802.1Qbg VSI Discovery and Configuration State Machine

V11

August 3, 2010

Expressing Bridge Resourcing States

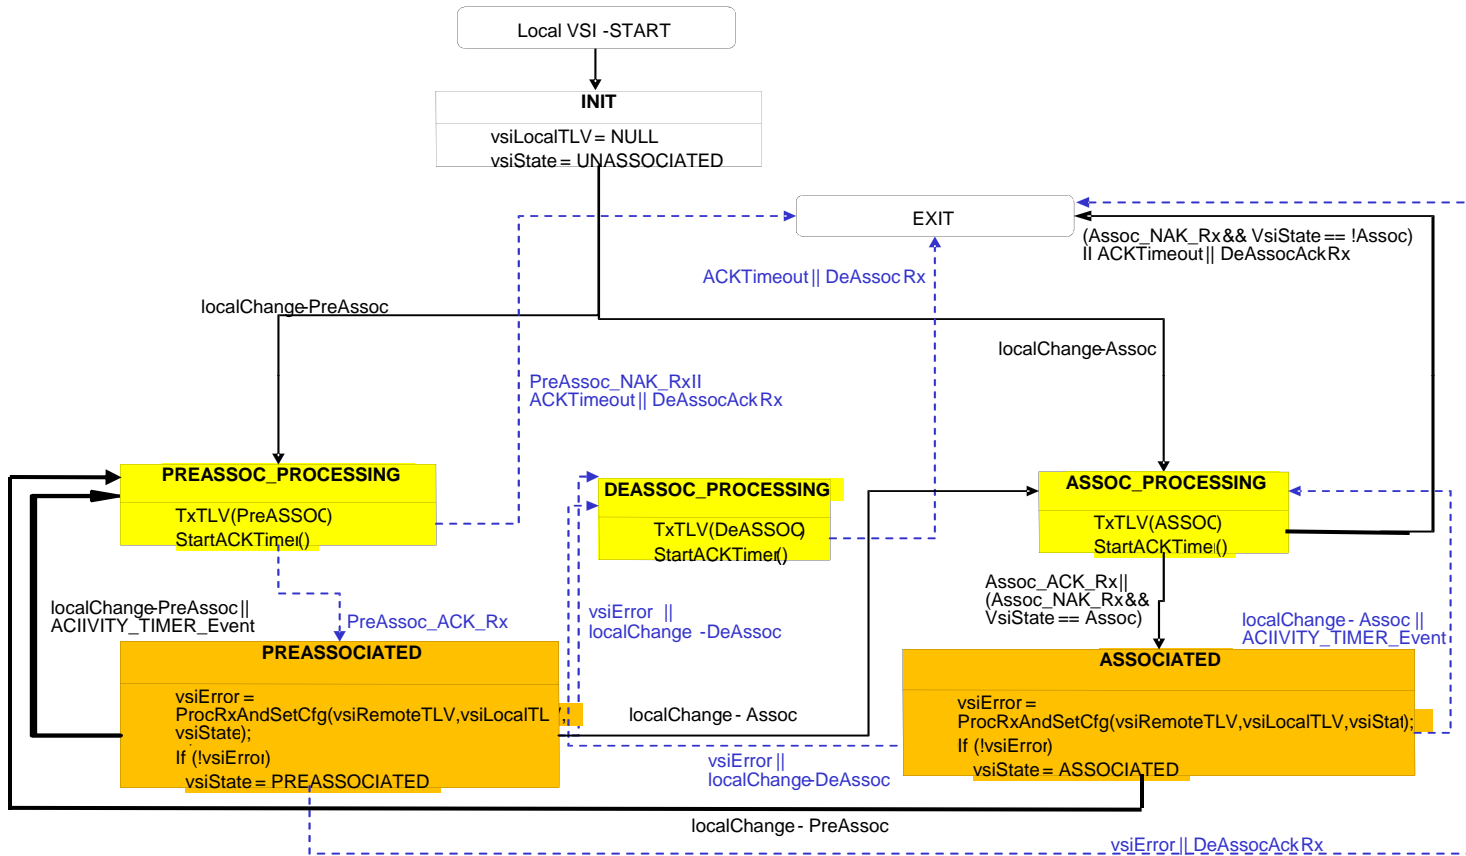
- Current state machine expresses the Bridge side resourcing request as a procedure hand-off.
- The bridge state machine hands the command to another machine which may query network management system before sending a response.
- It is convenient to break the command request into two states to allow time-out for the command hand-off
 - Need a timeout for the resource request from the Bridge
 - Need to build the response for the station from the resource request response

VDP Draft 1.0: State consolidation

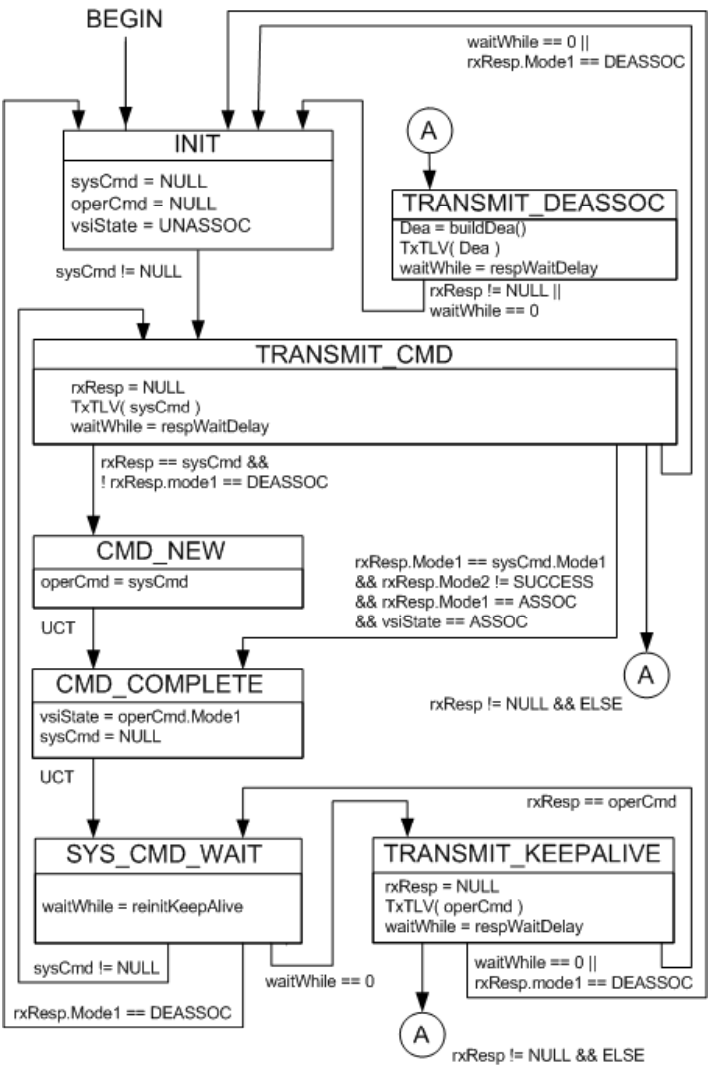
- Yellow states may be consolidated
- Orange states may be consolidated
